UNITED STATES PATENT AND TRADEMARK OFFICE

APPLICATION NO.	FILING DATE	FIRST NAMED INVENTOR	ATTORNEY DOCKET NO.	CONFIRMATION NO.
10/800,730	03/16/2004	Sang-Yeon Pyo	1594.1369	1852
21171	7590	08/15/2005		
STAAS & HALSEY LLP SUITE 700 1201 NEW YORK AVENUE, N.W. WASHINGTON, DC 20005			EXAMINER GRAVINI, STEPHEN MICHAEL	
			ART UNIT	PAPER NUMBER
			3749

Office Action Summary

DETAILED ACTION

Fig. 4

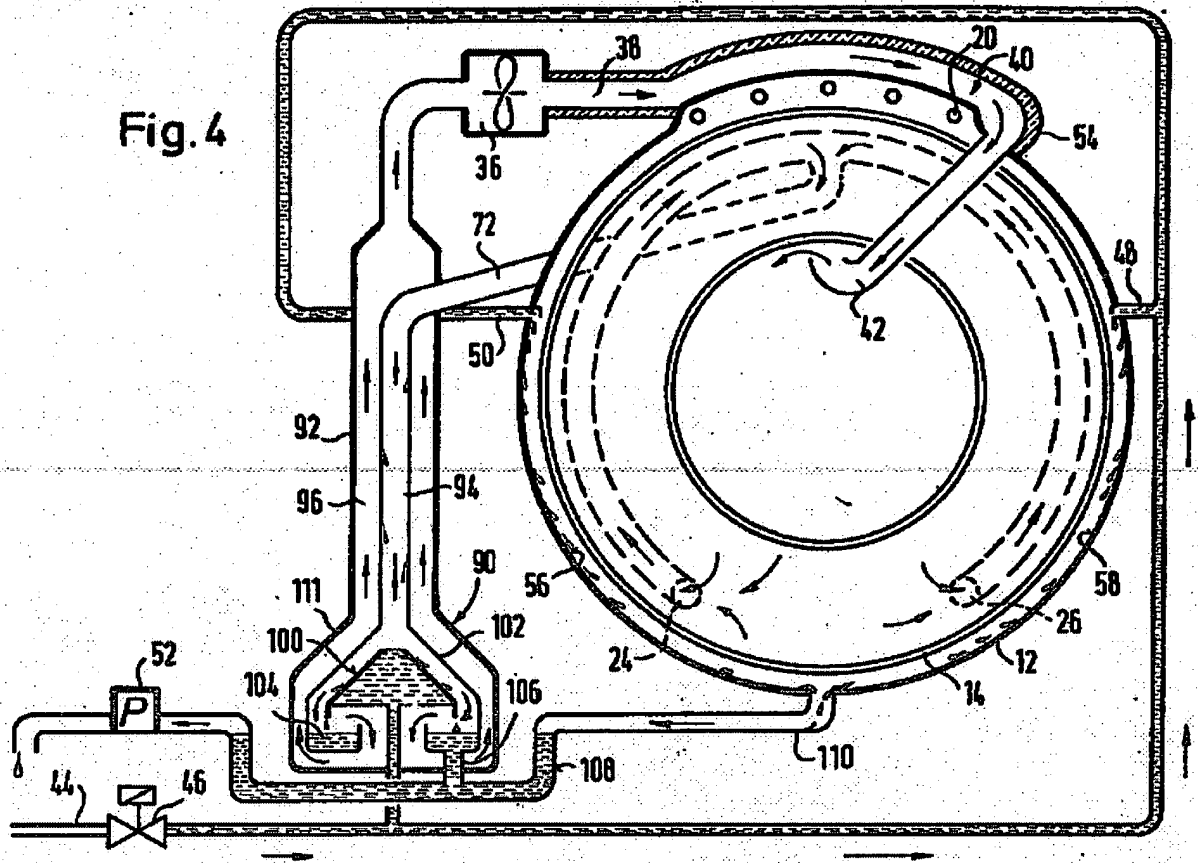
Current Office practice allows claims to be broadly construed in reasonable light of the specification. Applicants argue that primary reference Muller does not anticipate the claimed invention because at least one air guide to partition an inner space of a condensing duct into a plurality of condensing paths which communicate with each other in series is not a broad and reasonable interpretation requiring separation of an inner space of a condensing duct. Examiner broadly and reasonably construes the claimed separation recitation to be fully anticipated as discussed above. Both figures 4 and 5 of primary reference Muller are considered to fully anticipate the claimed invention when compared to applicants' figure 3, included below.

In this case, it can be seen that the claimed feature including at least one air guide to partition an inner space of a condensing duct into a plurality of condensing paths which communicate with each other in series is shown in each of the two primary reference figures 4 and 5 and applicants' figure 3. The anticipatory rejection is considered proper and maintained.
